**SEISMIC AND STRUCTURAL REVIEW OF ADVANCED MEDICAL SYSTEMS
LABORATORY FACILITIES**

June 6, 1996

NUCLEAR REGULATORY FACILITY INSPECTION REPORT ON THE ADVANCED MEDICAL SYSTEMS LABORATORY FACILITY

Figure A-1. Masonry pilasters and steel columns.

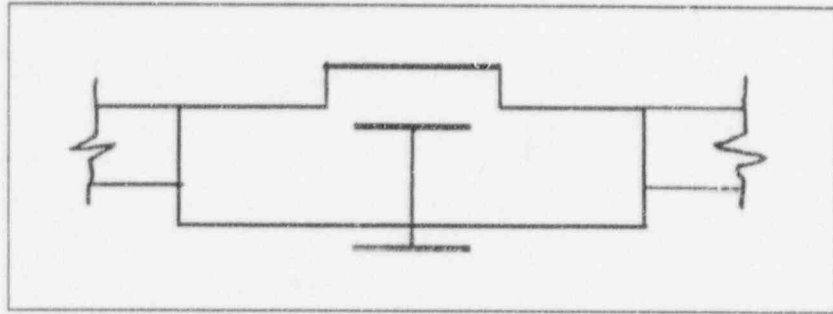
3.1 CONCERN-4/2/1: *The 1958 design, development and construction...encompassed the integration of a then existing warehouse/industrial building, with masonry load bearing walls and steel trusses as the roof framing steel...* This item was not a concern but a response is needed for clarification.

3.1 RESPONSE: The warehouse/industrial building referred to is not a complete load bearing masonry wall building with steel trusses, although at first glance it may appear to be. The building was constructed in 1934 as rectangular in shape. The east-west walls, the walls in the longer dimension (~100 ft), are non-load bearing masonry in-filled walls between steel-riveted columns that support the steel trusses. Some small amount of roof load between the trusses was originally carried by the east-west masonry wall, but this load was one-half of a purlin load, thus the wall typically would not be considered a load bearing wall. The tops of the east-west walls are basically unsupported in the out-of-plane direction except at the columns. At the columns, the masonry is placed flush with the column webs and a pilaster is built around the column flanges facing the original exterior of the building, with about six inches of brick covering the flanges. The sketch in Figure A-1 demonstrates the construction. Based on research done in the last 10 years (Henderson, et al., 1995), unreinforced masonry in-filled buildings provide excellent seismic resistance in low to moderate seismic zones. Although the 1935 building is not a true in-fill since the upper masonry walls are not confined by beams, the fact that they are in-filled within the floor and columns should provide lateral capacity of the building superior to a typical unreinforced load bearing wall. This is especially true where the old windows were filled in with masonry.

The north-south walls, the short dimension (~60 ft) of the building, are also constructed in the same fashion as the east-west walls. The only difference is the vertical columns at pilasters do not support any vertical load and the wall itself, between columns, supports one-half of the roof load that the trusses and columns support.

Figure A-2. Ceiling water damage.

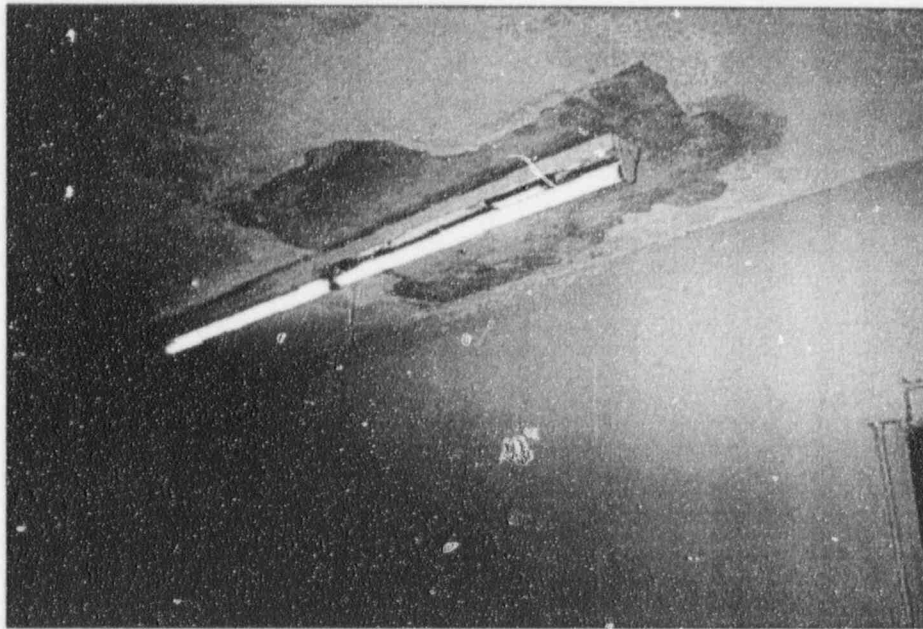
5.1 CONCERN-6/4/2: *In this area there is evidence of considerable amounts of water or other fluid apparently having penetrated on the second floor of the facility...*

5.1 RESPONSE: Two chases, one for electrical service conduit and one for ventilation, penetrate the second floor from the first floor into the equipment room on the second floor. The equipment room has a 10-inch riser around its perimeter, including the two doors, giving the impression that approximately 850 gallons of fluid would have to be spilled for a leak

outside the area to occur. This may have been the original intent; however, at both the conduit and ventilation chases, the risers are only two inches. In addition, at the ventilation chase, the riser has a 1½-inch notch in it. Thus, the maximum fluid that can be contained within the equipment is about 40 gallons. Therefore, the fluid runs over the ½-inch riser, down the chase onto the false ceiling. The first time a leak of significance occurred, the fluid collected in the false ceiling and was held there until the plaster of the false ceiling gave way as shown in Figure A-2.

This leakage caused no deterioration of the second floor slab's structural strength, and the fluids did not penetrate the concrete floor slab. There is no visible degradation of the floor slab, and it is highly unlikely there has been any degradation. In addition, the main part of the equipment room is over the radiography room where the floor slab is 2-feet thick.

Figure A-3. No ceiling tile water damage but evidence of fluid on the wall

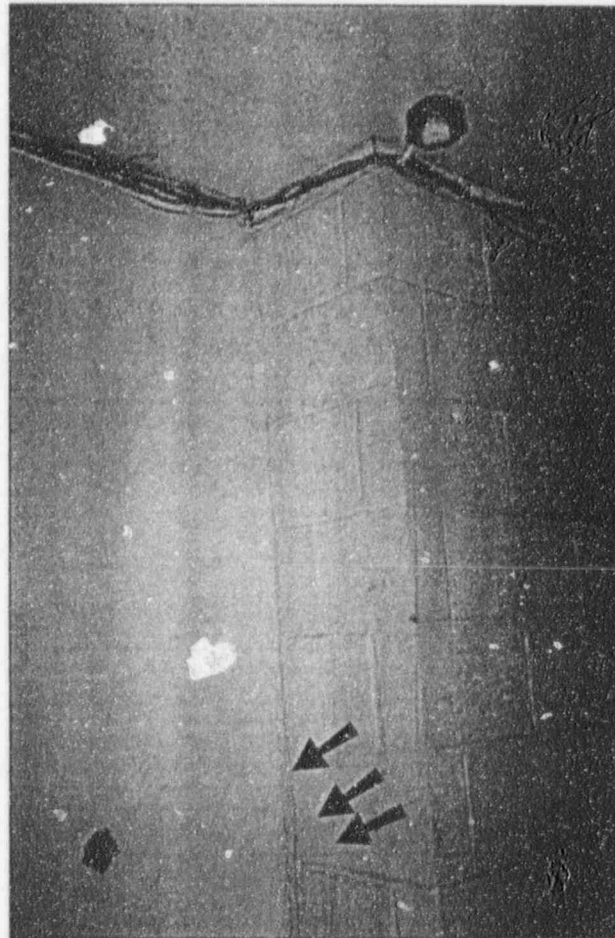
5.2 CONCERN-6/4/4: *Evidence of the fluid that penetrated exists on the ceiling adjacent to the hot cell and in front of the radiography room and around the corner of the radiography room into a hallway at the north side of the radiography room. (This was not a concern but a response is needed for clarification.)*

5.2 RESPONSE: The first inspection of this AMSLF was conducted by this reviewer on April 30 through May 1, 1996. At that time, no ceiling water damage was noticed around the corner of the radiography room into a hallway at the north side of the radiography room.

A second inspection was conducted on June 3 to determine the discrepancy. While no water damage was noted in the false ceiling, it was quite apparent that fluid had run down the wall as shown in Figure A-3.

Figure A-5. Cracking on the inside wall.

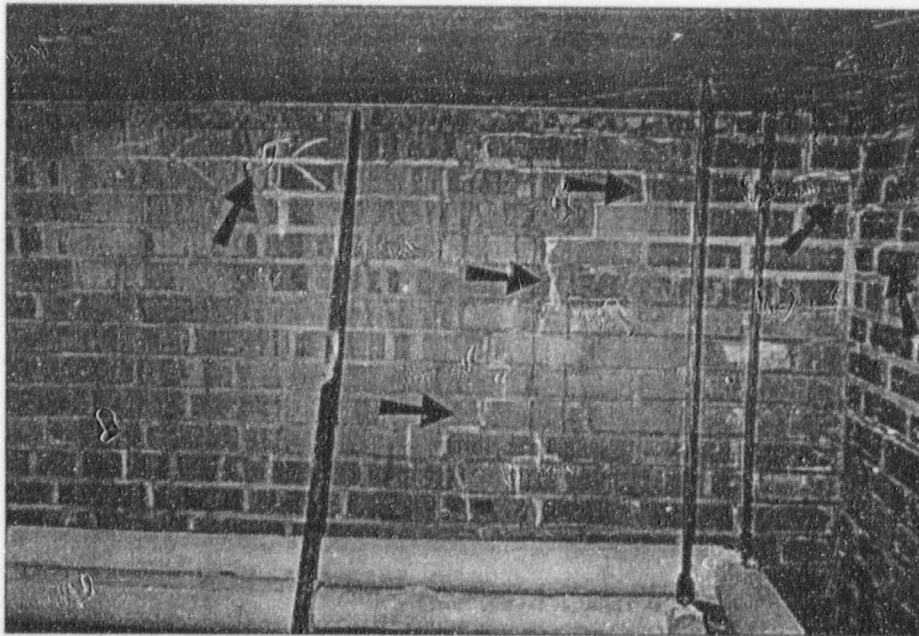
5.7 CONCERN-7/2/1: *The distress at the southeast corner of the building associated with the east 3-wythe load-bearing brick masonry wall...extending over approximately 4 feet vertically. The open crack, representing ... in the once continuous load bearing masonry wall that is 12 and 1/2-inches thick (Dwgs A-10 and P-2).*

5.7 RESPONSE: As described in the NRC report, cracking does exist and is shown in Figure A-4. From the outside, the cracking appears to stop just short of the area where the second floor slab ties into the common wall brick. From inside the building below the second floor, it is evident that cracking does extend through the wall; however, it is not continuous, i.e., the cracking on the inside of the wall is almost an opposite pattern, as shown in Figure A-5.

From inside the building above the second floor, the east and south walls in the corner show no cracking; however, as shown in Figure A-6, there are four cracks in the second floor slab that are visible to the human eye. One very large crack is nearest the corner, is at an approximate 45° angle to each wall, has a width of one-half inch, and has a length from wall to wall of about six inches. Based on the width of this crack, it must be assumed that the crack continues through to the slab edges underneath both the east and south walls. No reinforcing steel was found in this crack. A second crack runs almost parallel to the south wall, appears to cross the third crack, and then merges into the fourth crack. The third and fourth cracks are also at about a 45° angle to each wall. Based on the width of the crack nearest the corner, it appears that the southeast corner has moved southeast a distance of as much as $\frac{1}{2}$ to $\frac{3}{4}$ -inch. These floor cracks seem to indicate excessive bending moment in the floor slab at this corner, which would be indicative of significant settlement at the corner. Underneath the second floor slab, matching crack patterns were found. It was determined that the as-built dimension of the floor slab was six inches.

Figure A-8. Purlin and Wall Movement.

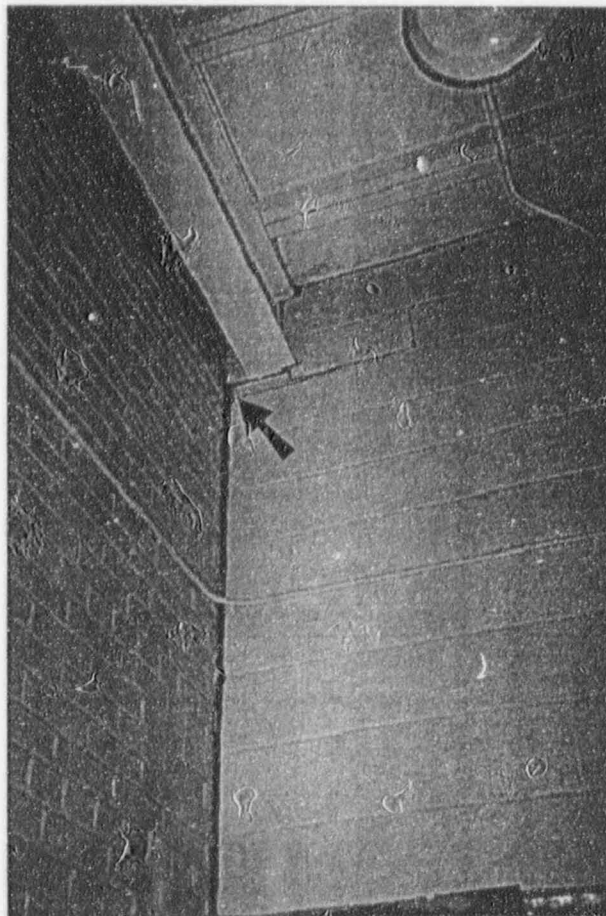
5.14 CONCERN-7/4/14: *In addition to the cracking of the east wall, evidence of lateral loading was found at a point about 17-feet...Rupture of the joints of this wall where the masonry was fit around the purlin as occurred...*

5.14 RESPONSE: It is the opinion of the reviewer that this movement has nothing to do with what has happened at the southeast corner of the building. The biggest problem with the construction of this building is that none of the interior non-load bearing walls were interlocked or tied in with any of the structural members, and most of the non-load bearing walls have separated leaving visible cracks from adjoining walls. The location of the cracking in question is shown in Figure A-8 and, as indicated in the NRC report, the crack opening is approximately one inch. This wall is the west side of a right angle interior wall forming a small room in the southeast corner. If the north side of the interior wall is compared to the paint lines on the roof decking, it is evident that the entire top of the non-load bearing wall has moved northward about one inch. There is no evidence that the purlin has moved southward at this location.
